Moorhead Area Public Schools Improvements Robert Asp Elementary School Addition Moorhead, MN

Project No. 13-041

Date: April 3, 2014

ADDENDUM No.1

M7.1

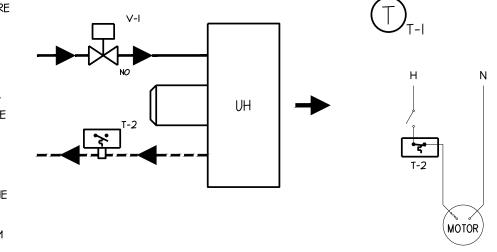
- 1. Add Roof Hood schedule and Louver schedule attached to this addendum as R-1/M7.1.
- 2. Revise pump P-4 as shown on Pump Schedule on R-1/M7.1.
- 3. Air Handling Unit Schedule; Change the "DISC BY" on AHU-1 and AHU-2 to "ATC" for Automatic Temperature Controls. Change shall be for both supply and return fans on both air handlers.

Sheet M8.1:

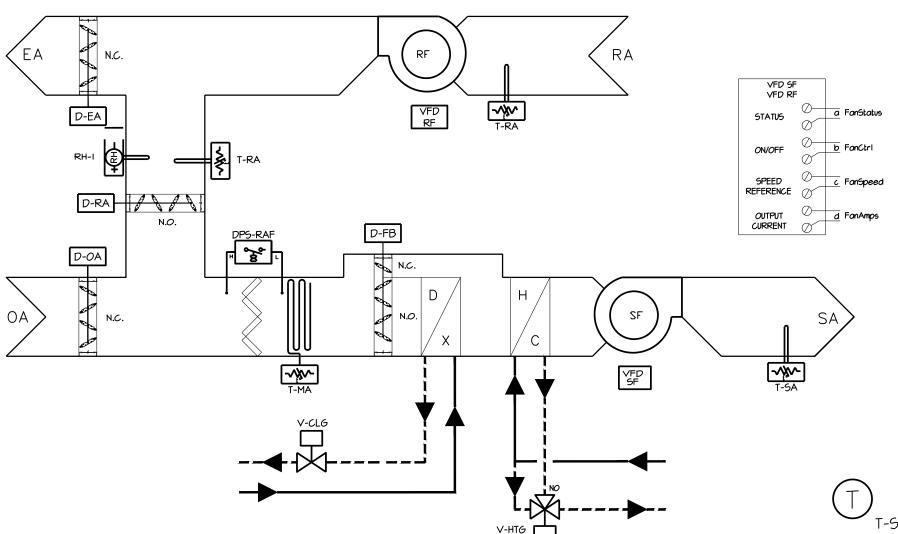
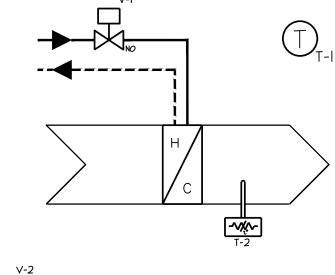
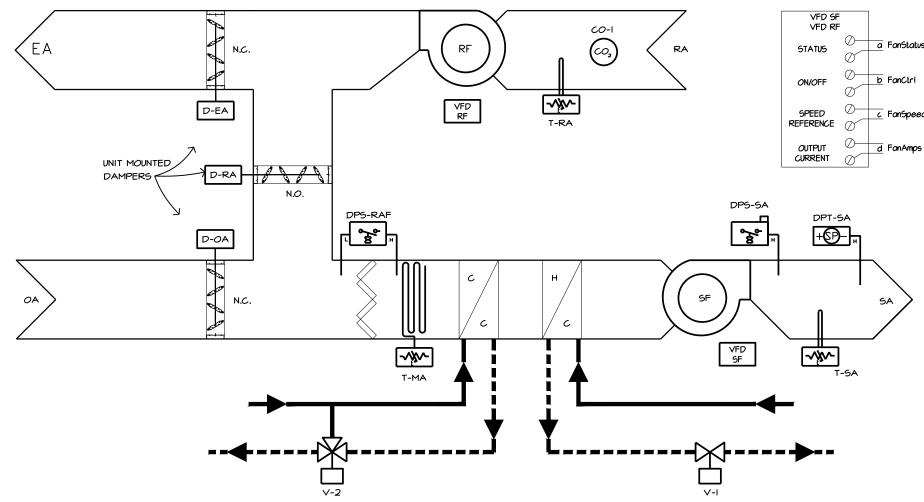
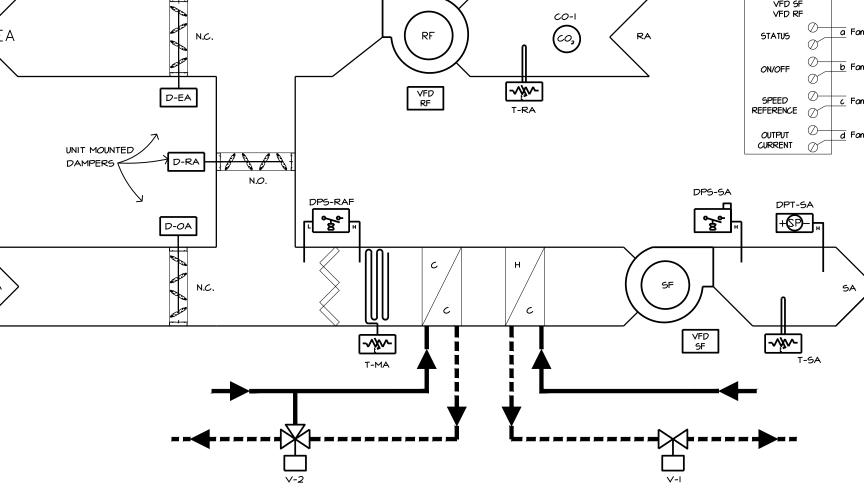
1. Add the attached sheet M8.1, Control sequences to the drawing set.
